#### **REMARKS/ARGUMENTS**

In the office action mailed August 18, 2003, claims 1-6 are pending. Claims 1, 3, and 5 are rejected and claims 2, 4 and 6 are objected to. The arguments below follow the order set forth in the office action.

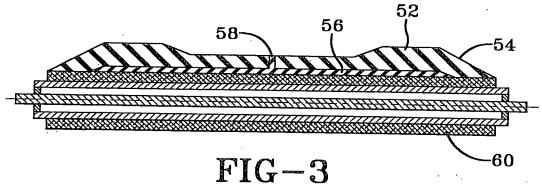
In summary, in Fig. 1, numeral 39 has been added and the lead line to numeral 38 has been changed.

FIG-4

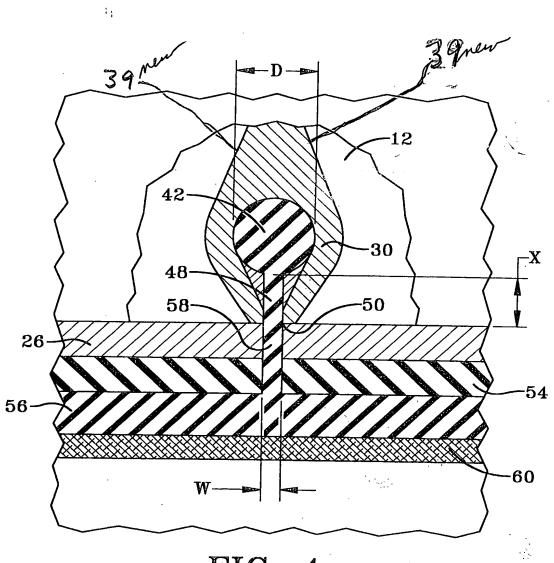
The drawings were objected to because the tapered walls of claim 4 to divert the flow of the outer tread around the chimney block of claim 6 must be shown. The tapered walls are shown in Figs. 1 and 4 and described on page 5, lines 6 – 8, where the "flow splitting tapered upstream edge 38 of tapered walls 39" is set forth. Figs 1, 2 and 4 have been amended by changing the lead line to numeral "38" to identify the tapered upstream edge and numeral "39" added to identify the "tapered walls." Showing the tapered upstream edge 38 clearly identifies the "tapered walls 39" which create the edge. Reconsideration of this objection is respectfully requested.

In Fig. 4, numeral 39 has been added. Marked up copies of the drawings showing these changes in red are also enclosed. A Request for Drawing Amendment is being filed simultaneously herewith.
